ADDENDUM NO. 1

RFQ CCC-078

**Administration Building Renovation
Compton Community College District**

tBP Project. No. 20987.00

6. Revised SHEET A2-1 REFLECTED CEILING PLAN -RENOVATION

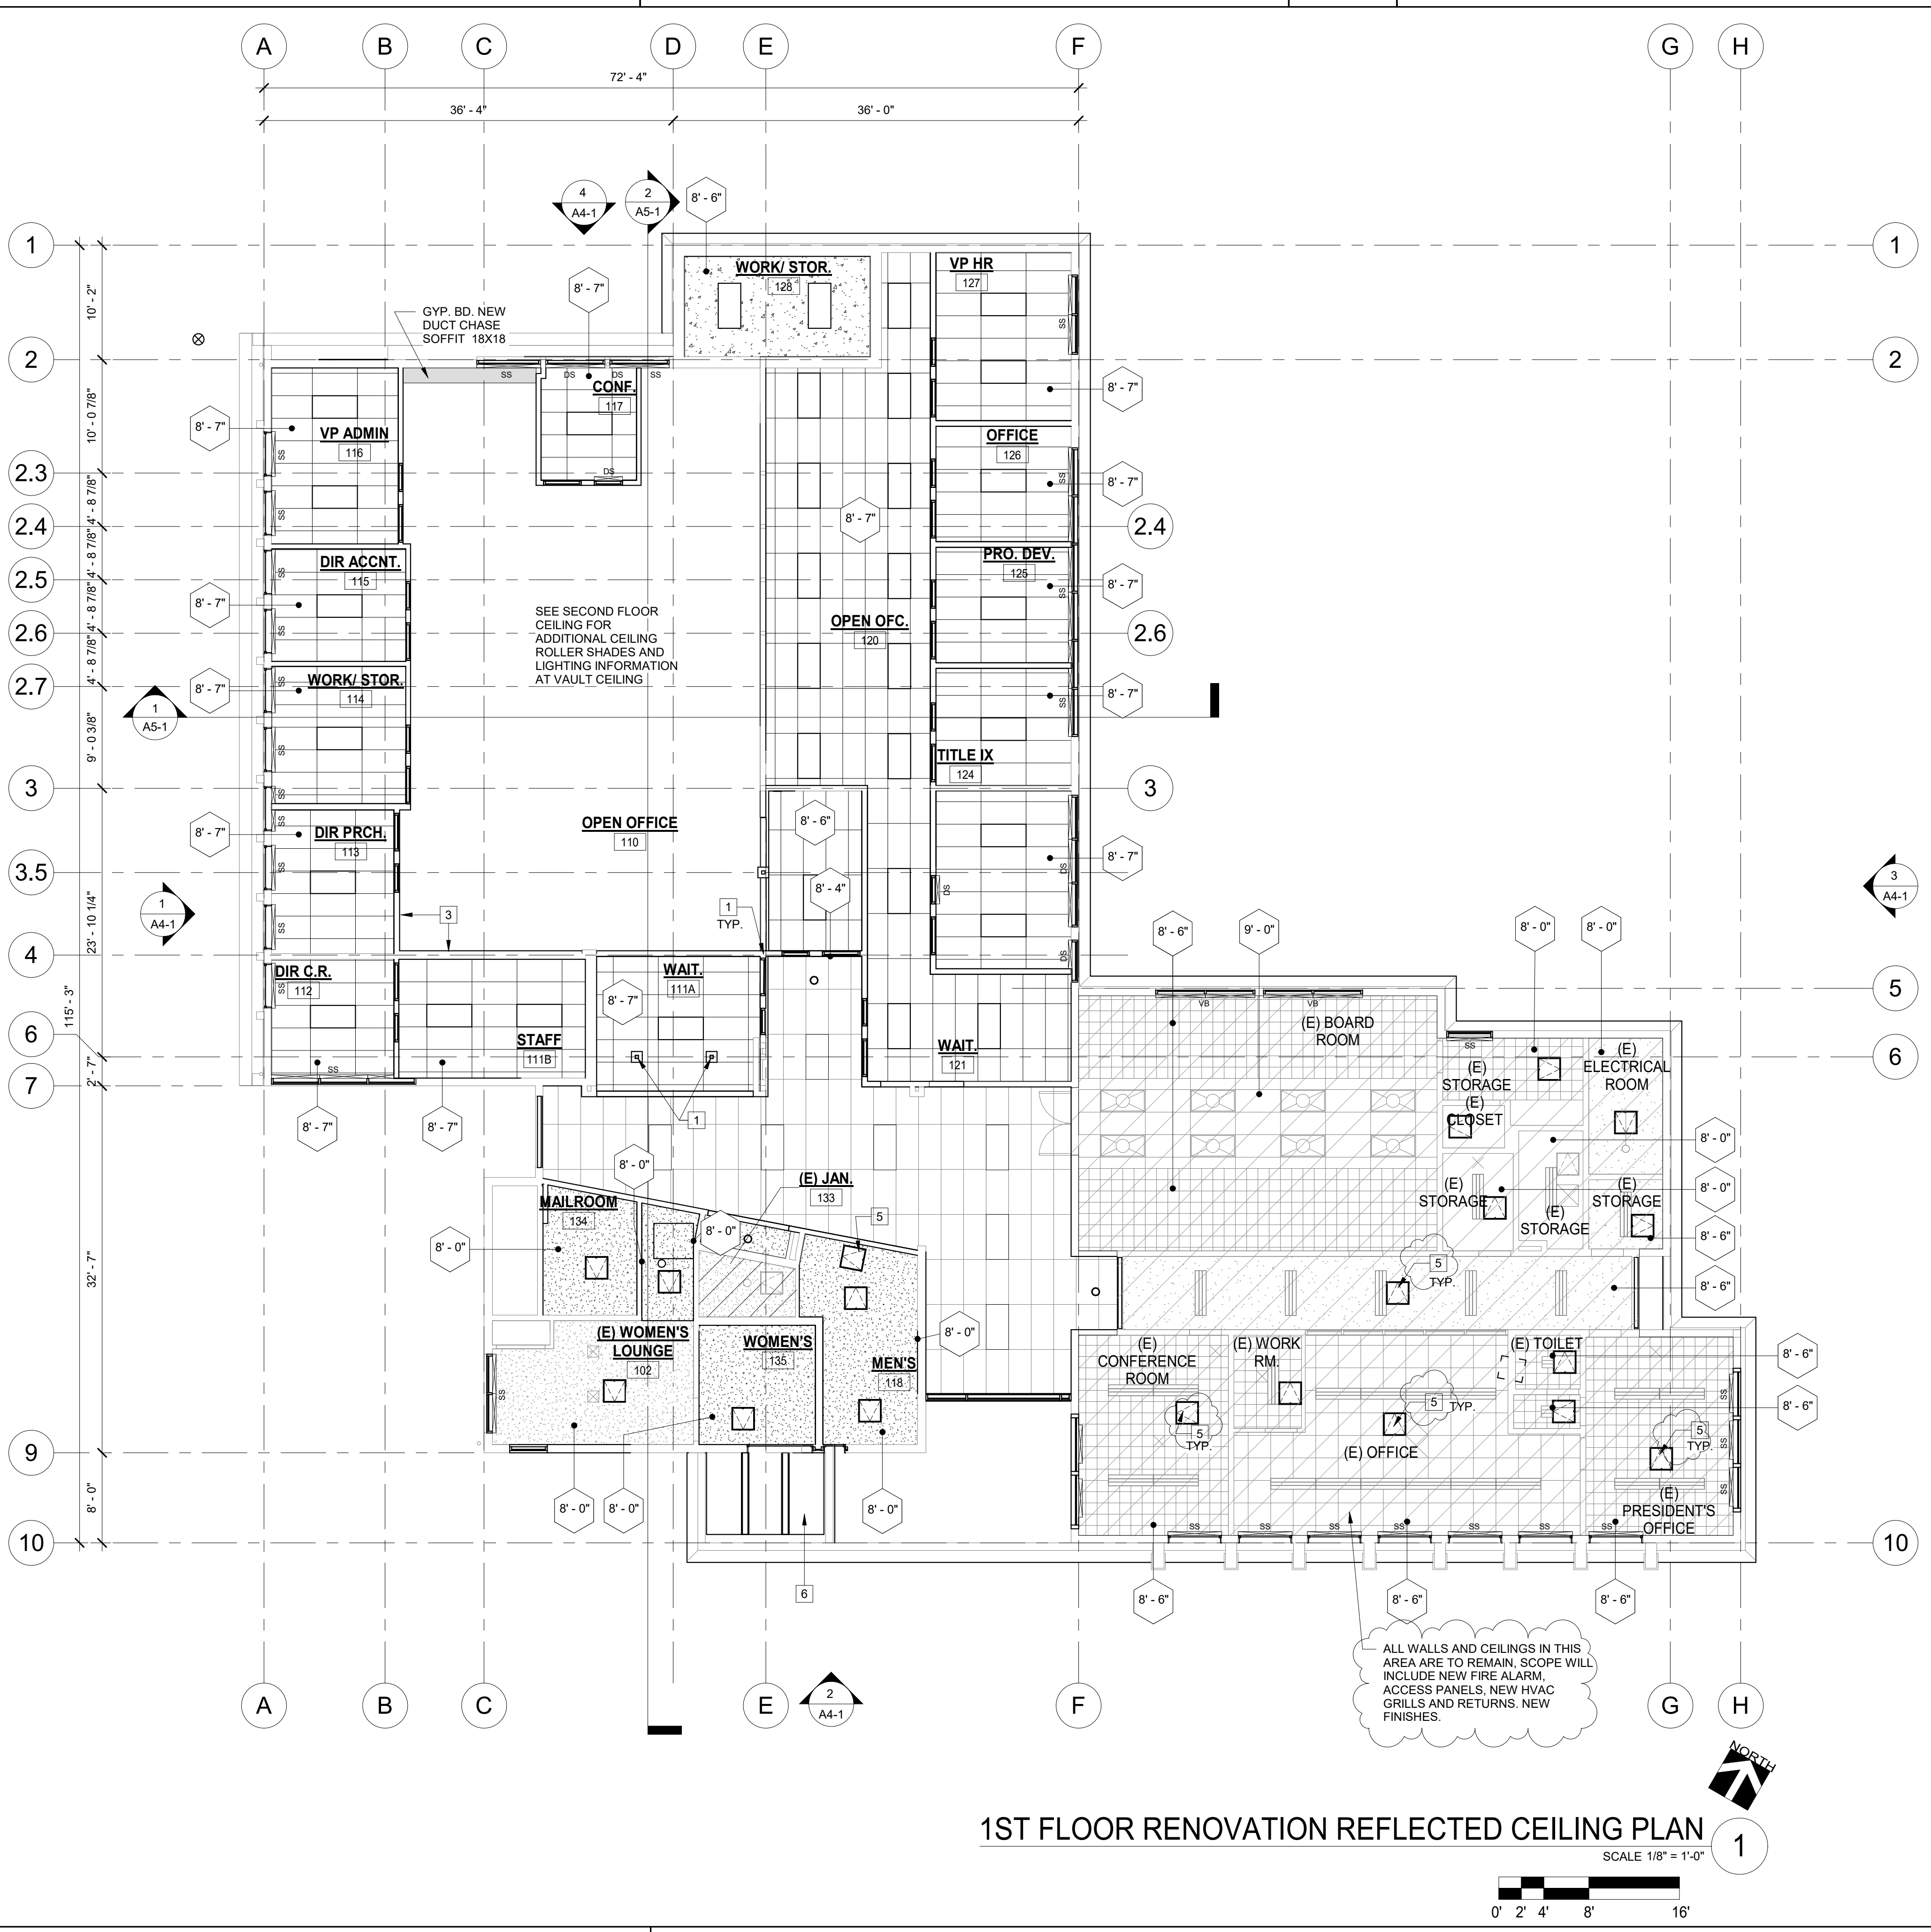
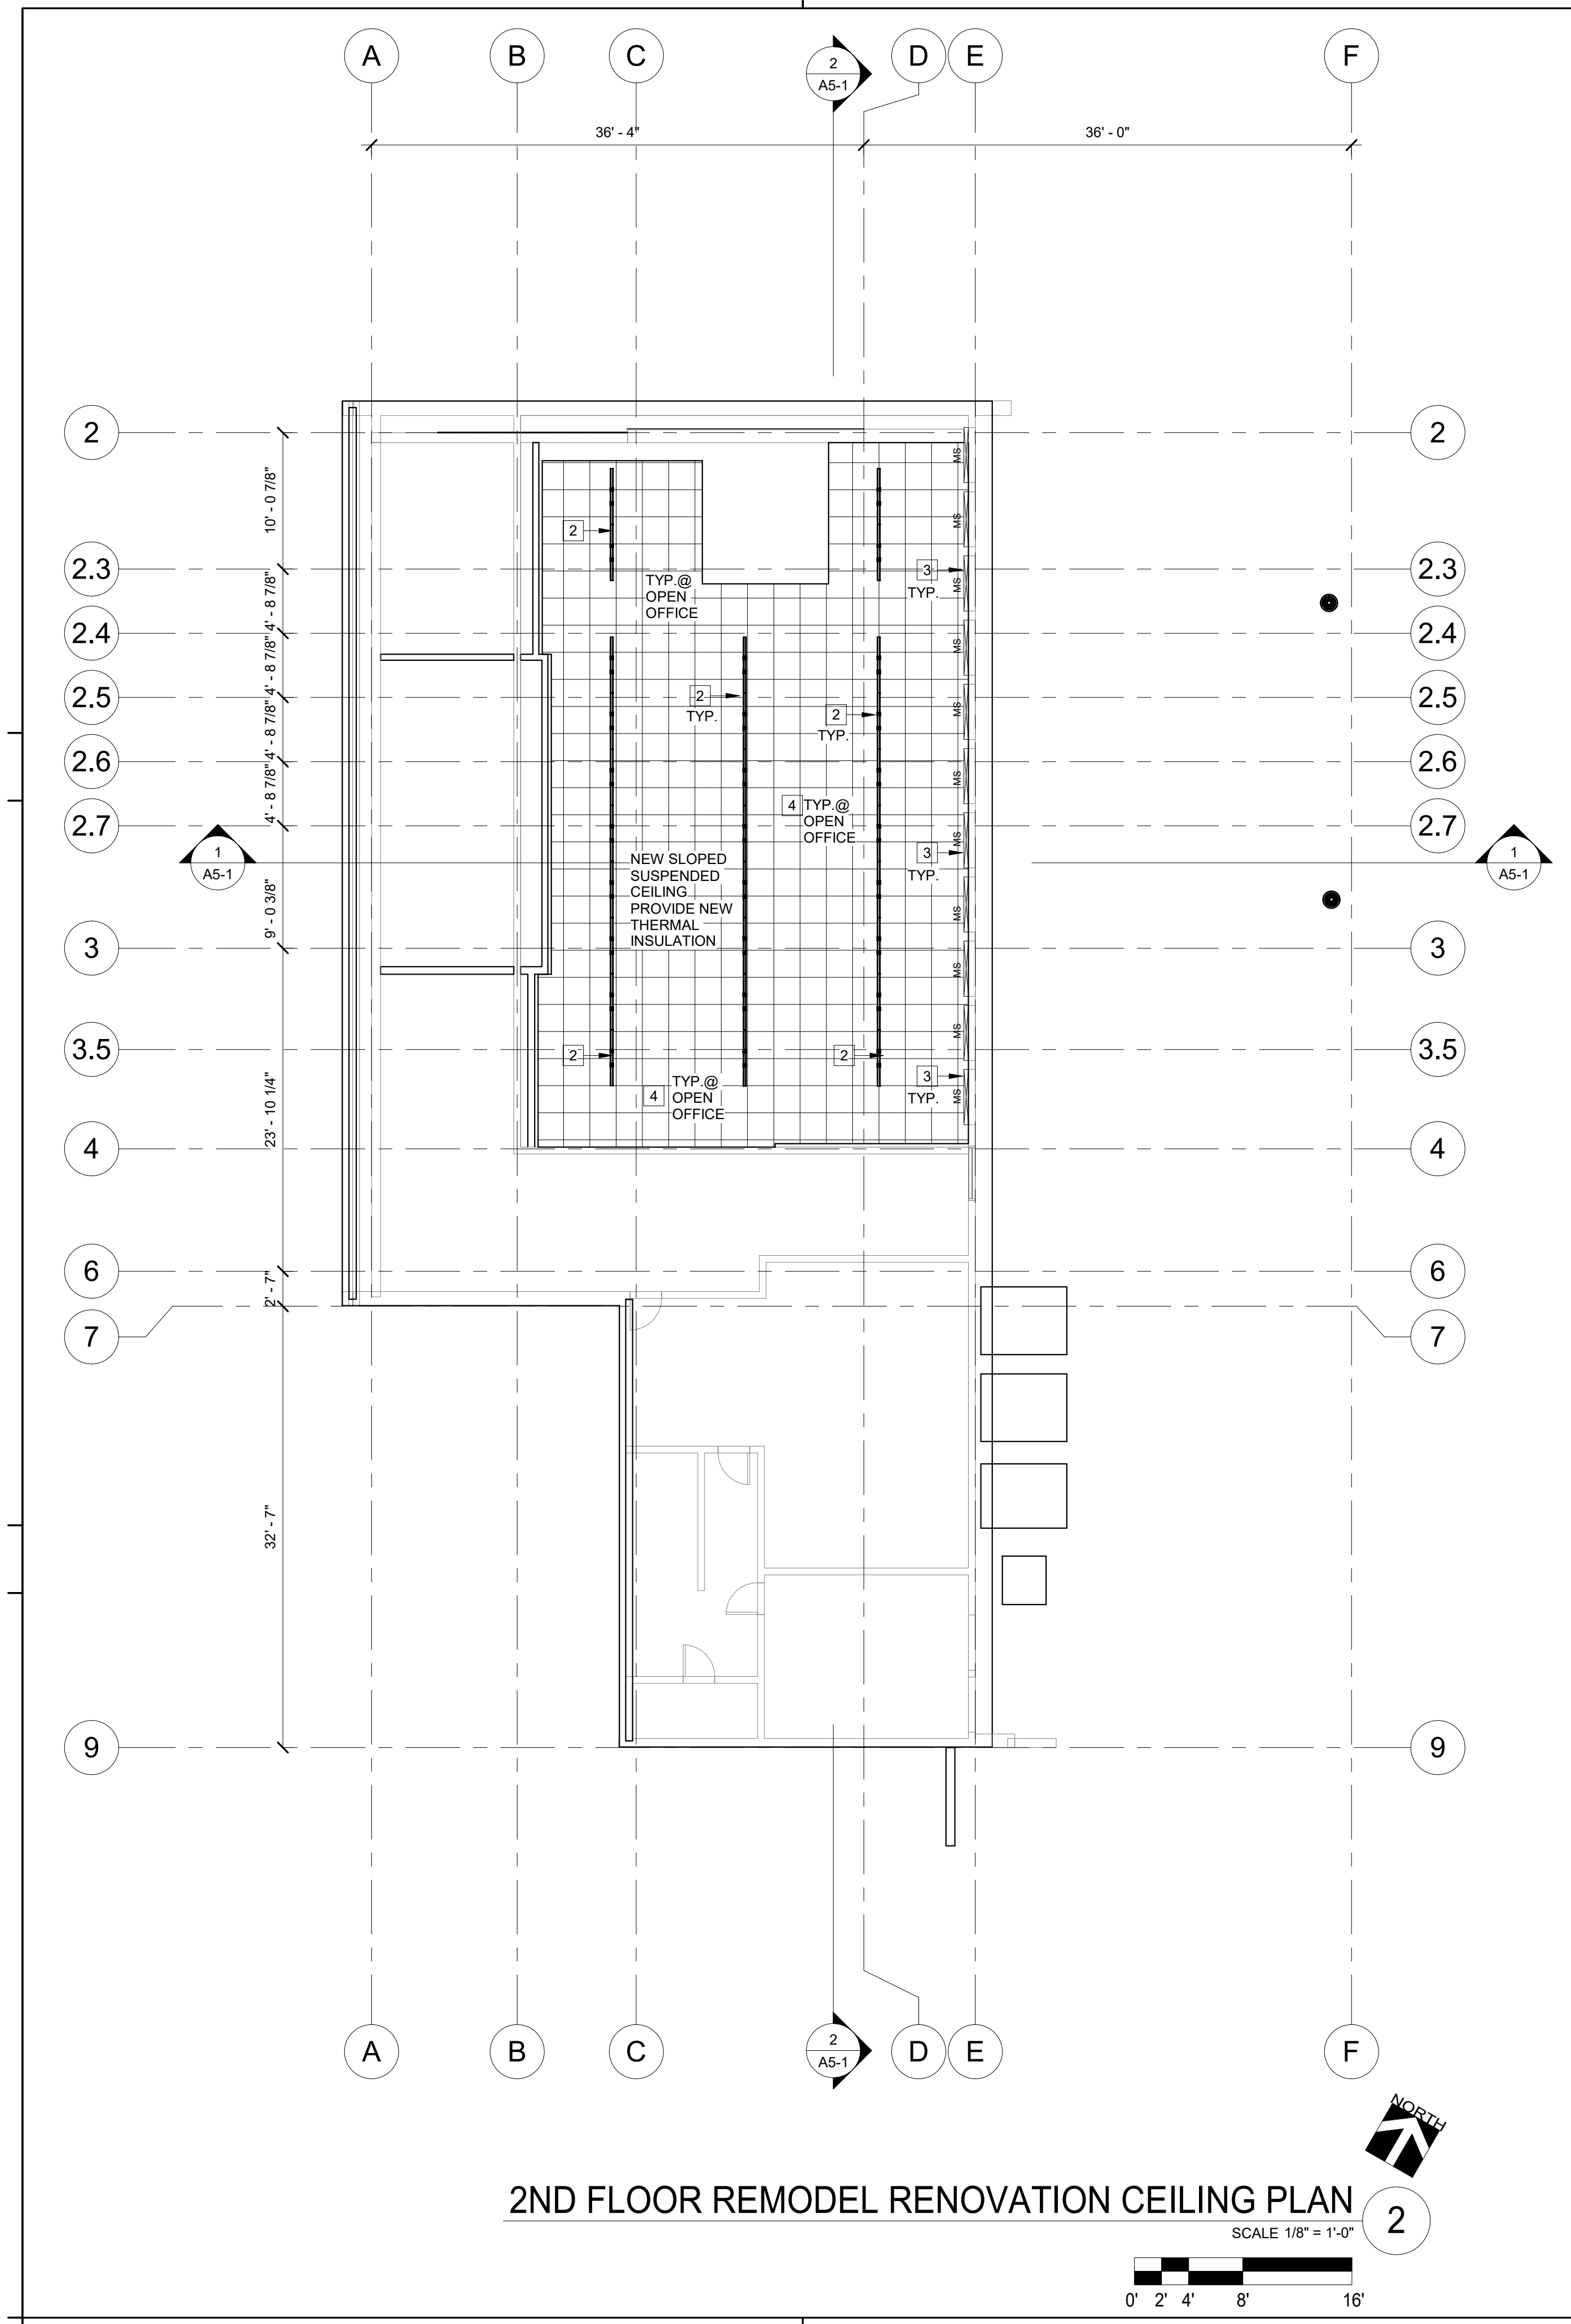
- a. Corrected general notes and key notes to clarify ambiguous scope notes.
- b. Deleted repeated notes on roller shades.
- c. Clarify notes on access panels required for fire alarm upgrade.
- d. Revised the ceiling and lighting in the Lobby area.
- e. Reworded key notes for clarification.
- f. Removed window shades from scope except the ones at the clearstory windows in room 110.
- g. Added vertical shades in the Boardroom.
- h. Clarified legend.
See attached Full size sheet identifying revisions included as part of this addendum.
